**MARINE AND COASTAL ACCESS ACT (2009) VARIATION APPLICATION BY SOUTH TEES DEVELOPMENT CORPORATION FOR THE DISPOSAL OF CAPITAL DREDGING FOR SOUTH BANK PHASE 1 AT TEES DOCK, MIDDLESBOROUGH.**

**Reference Number: MLA/2020/00506/1**

From: Sylvia Blake  
Cefas, Lowestoft Laboratory  
Date: 10<sup>th</sup> June 2022

Figure 1. PC1084-RHD-SB-DN-SK-C-0014-P02.pdf Drawing showing proposed and existing MMO licence dredge boundary.

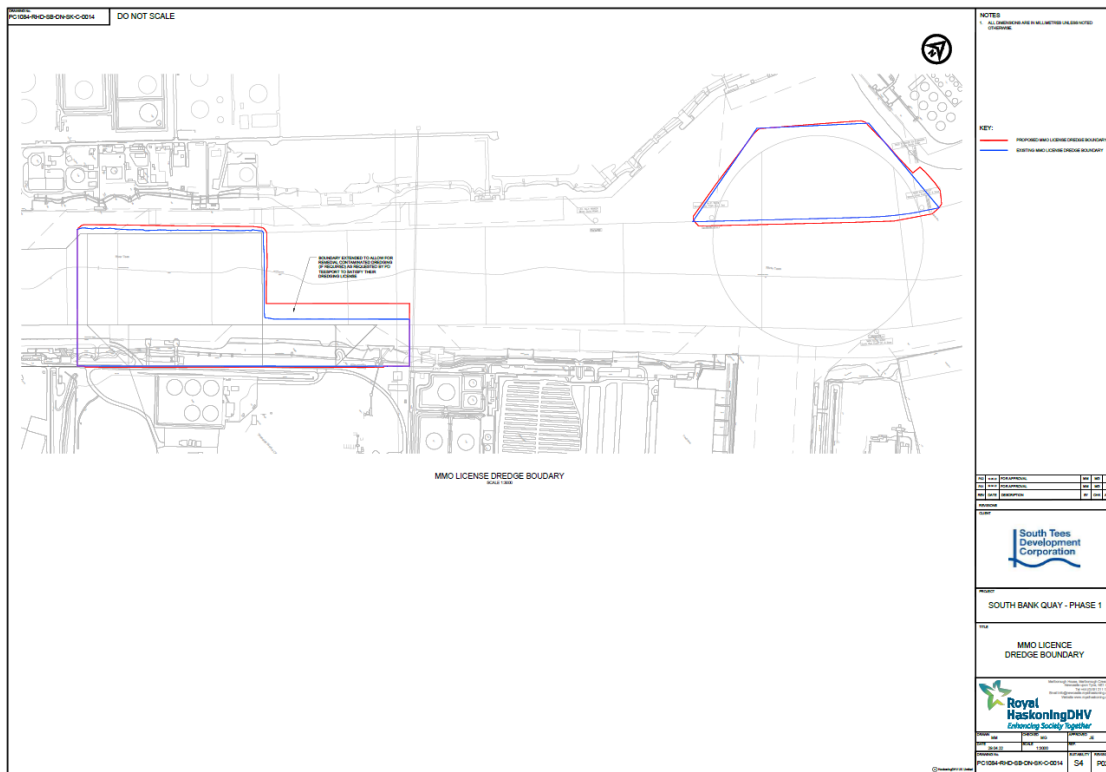
14. **Major comment.** Condition 5.2.1 of the licence describes an area for exclusion based on previous advice (Jemma Lonsdale to Emmanuel Malenga dated 6<sup>th</sup> April 2021) that material around borehole 34 be excluded based on sample results:

This exclusion area is directly south of the area labelled to allow for remedial dredging of contaminated material (Drawing copied in annex1 figure1 and Google Earth image of dredge

area and boundary points of exclusion zone -figure 2). Therefore, it is my opinion that this additional area should be sampled and analysed to determine its chemical and physical nature. I recommend the applicant seek advice from the MMO for a sample plan. To inform a sample plan it would be useful for the applicant to provide an estimate of the volume to be removed from this additional area, the co-ordinates of the area, anticipated dredge depth, together with previous sample and analysis information from the adjacent area (including plotted locations of previous sample points).
